2. Trust Land Survey 2024-01 Lonesome Lake Sub. 2024 Addn. KPB File 2024-117

ITEM #2 - PRELIMINARY PLAT TRUST LAND SURVEY 2024-01 LONSOME LAKE SUBDIVISION 2024 ADDITION

KPB File No.	2024-117
Plat Committee Meeting:	November 18, 2024
Applicant / Owner:	Alaska Mental Health Trust Authority / Anchorage, AK
Surveyor:	David Hale / R & M Consultants, Inc.
General Location:	Between Lonesome Lake and Upper Cohoe Lake

STAFF REPORT

SURVEYED TOWNSHIP 3 NORTH RANGE 12 WEST OF THE SEWARD MERIDIAN, ALASKA

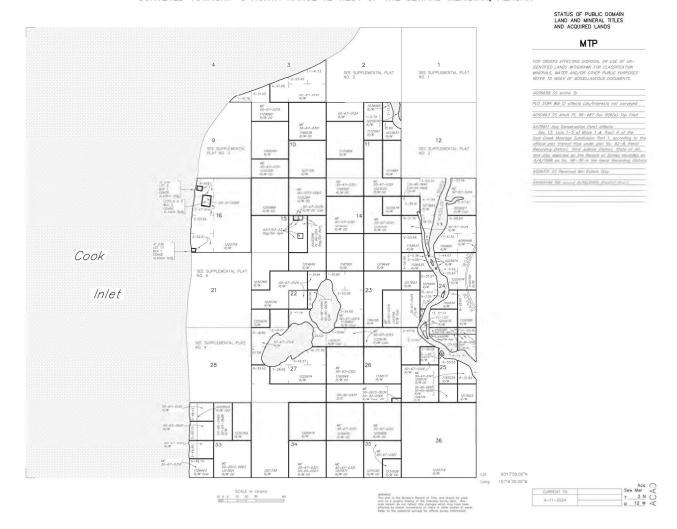
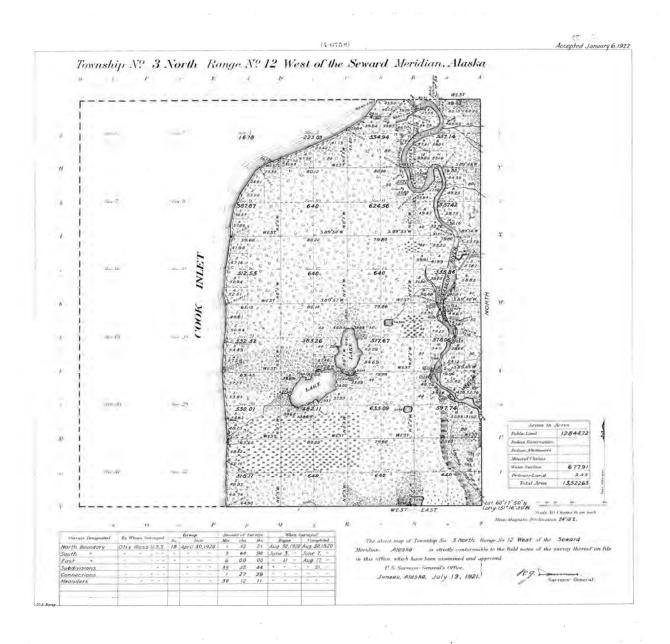
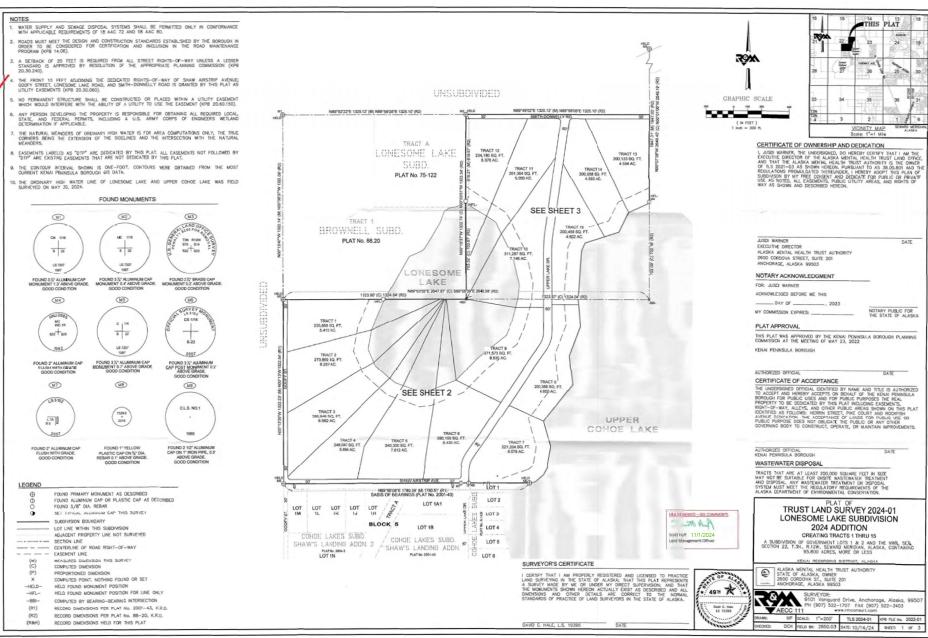
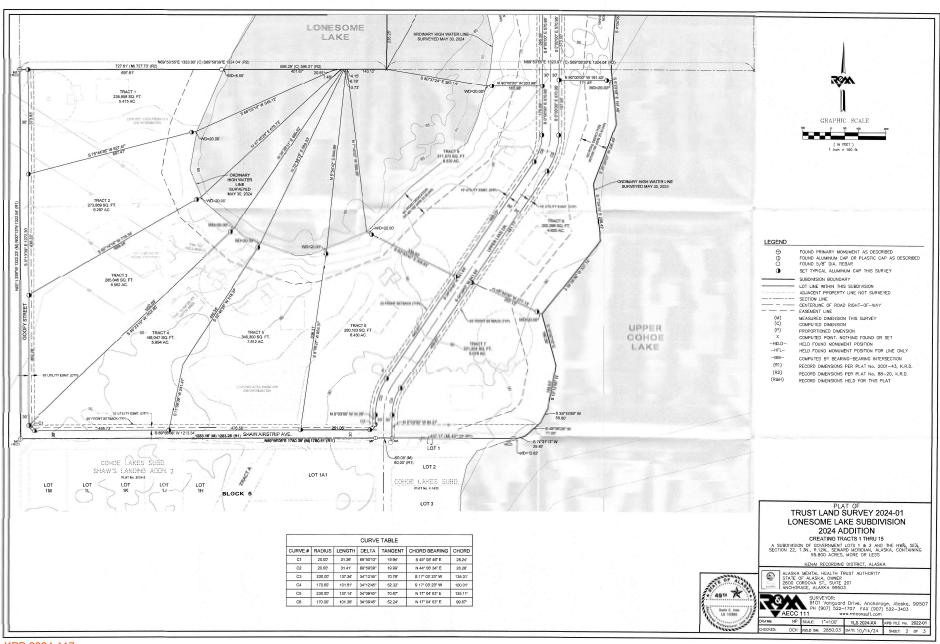
Gov't Lot 1 of the original division is affected by a section line easement on the east side above Upper Cohoe Lake. **Staff recommends:** the surveyor verify the width of the easement and odd the section line easement to the drawing. The plat appears affected by several patent easements. **Staff recommends:** the surveyor verify the in the certificate to plat and show the affects if possible and / or add a plat note to the affects.

There are wetlands shown on the plat. Lonesome Lake being one, but there are others shown too. On pages 2 and 3 there are areas outlined, the areas need to be designated better with hatching as the line outlining them is the same line being used to designate section lines only in a lighter form. Staff recommends: the surveyor find a different form to designate the wetlands and carry it forward to the final submittal.

Add the label to Tract 8 on page 3

There is double labeling of the road along Tracts 8 & 15 and 9 & 10 on pages 2 & 3, one needs removed per page The no road dedication label along the lakes is not needed and can be removed.

Plat note 4, Lonesome Lake Rd needs to be replaced with Upper Lake Rd.

Add KPB no. 2024-117 to the drawing

Verify if there is a section line easement on the east line of the subdivision. Data indicates a 50' SLE.

To the south of Upper Lake Rd adjacent to this plat is identified by other plats an access easement per plat K-1430 that should be noted

Add to the drawing, the dedications to the northwest from Lonesome Lake Subdivision Vacation & Replat and Brownell Subdivision Tract 1

Move the label of Sterling Highway higher on the vicinity map

Correct the road names in the Certificate of Acceptance

Several lots to the south of the plat need to have the labels and shape corrected

Low wet areas should be labeled with KWF Wetland Assessment designation

Low wet area line designation should be changed, is same line in legend for section line only lighter.
